draft-ietf-detnet-dp-sol-00 Issues

Detnet working group, IETF100, November, 2017

Norman Finn, Huawei

Which particular "pseudowire-ish solution"?

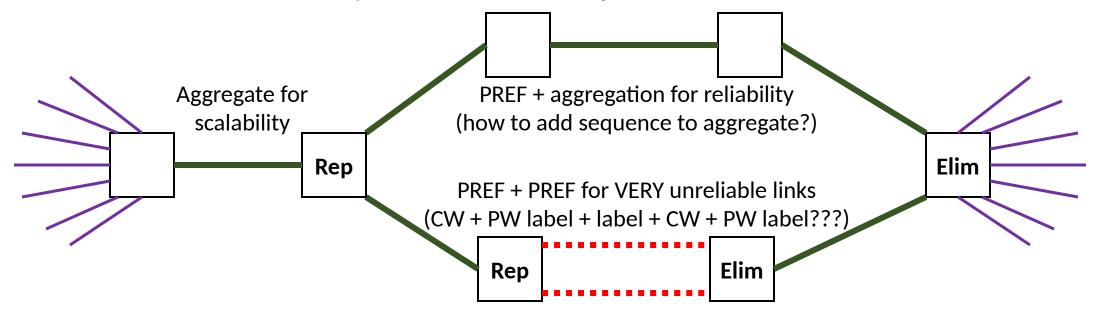
- Three ways to describe the pseudowire-ish solution are propsed:
 - dp-sol is based on RFC6073 Multi-Segment Pseudowires (MS-PW).
 - It could be based on RFC7432 BGP MPLS-Based Ethernet VPN (EVPN).
 - It could describe a brand-new construct, the "DetNet Wire" (DW).
- How much do these choices differ in the implementation of the data plane?

End-to-End PREF vs. "ladders"

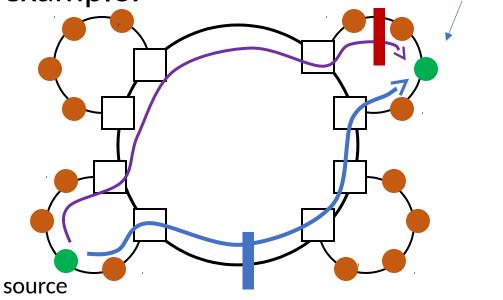
- End-to-end PREF, where only one point (at or near the source) replicates packets, and only one point (at or near the destination) eliminates packets, makes the solution much simpler.
- However, the authors feel that there are use cases where protection against just one failure is inadequate. For example:
- Factory floor: Main ring + attached rings.
- Planned break in main ring is required to add/delete attached rings.
- Planned break in main + unplanned break in attached ring = end-to-end failure.
 - 3 or 4 paths is a big burden on the host.

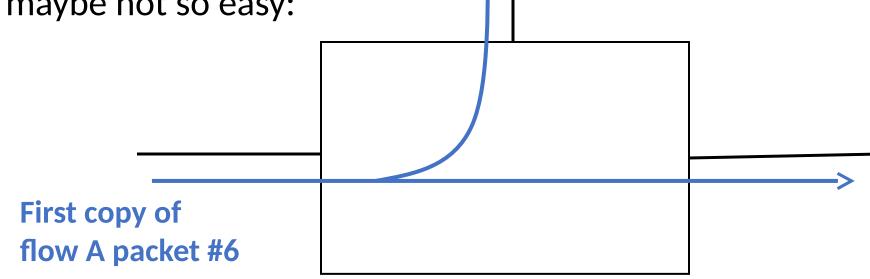
Various aspects of packet replication and elimination are discussed in all five of the adopted DetNet drafts: architecture, problemstatement, use-cases, dp-sol, and security.

• Elimination maybe not so easy:

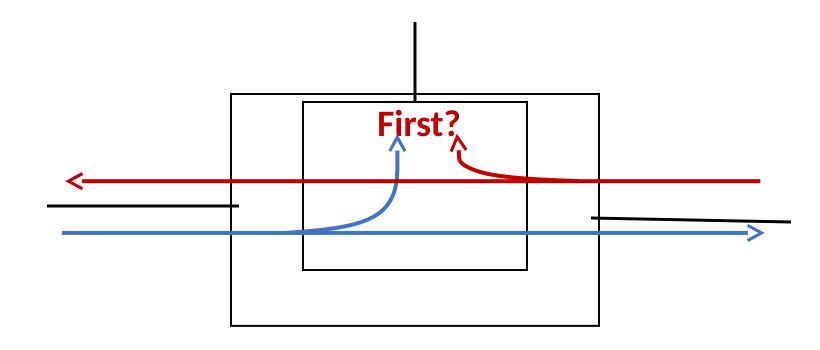
- Elimination maybe not so easy:
- (If red packet comes first, it goes to both output interfaces.)

Second copy of flow A packet #6

First copy of flow A packet #6

- If you have a "one-chip" router, then PRE may be easy to implement.
- If you have a "federated" router, with multiple line cards and an interconnect, PRE may be relatively more difficult to implement.
- It is common to make all decisions in the "ingress" line card. The line cards are stupid in the output direction.
 It is not easy to distribute the question, "Which is first?"

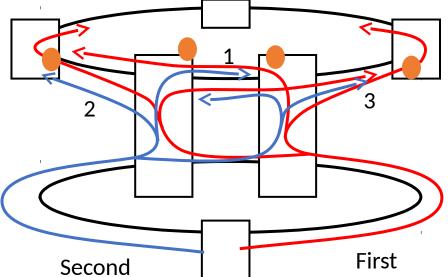
We could allow the packet elimination function to be moved to the other end of the wire by defining an elimination function that works

on the input side.

• If you have the bandwidth to carry all copies of all the flows that use a

given link, this can work.

• (E.g. IEC 62439-3 "quad box" with input-only elimination uses 2x bandwidth on link 1 and 2x or 3x bandwidth on links 2 and 3.)
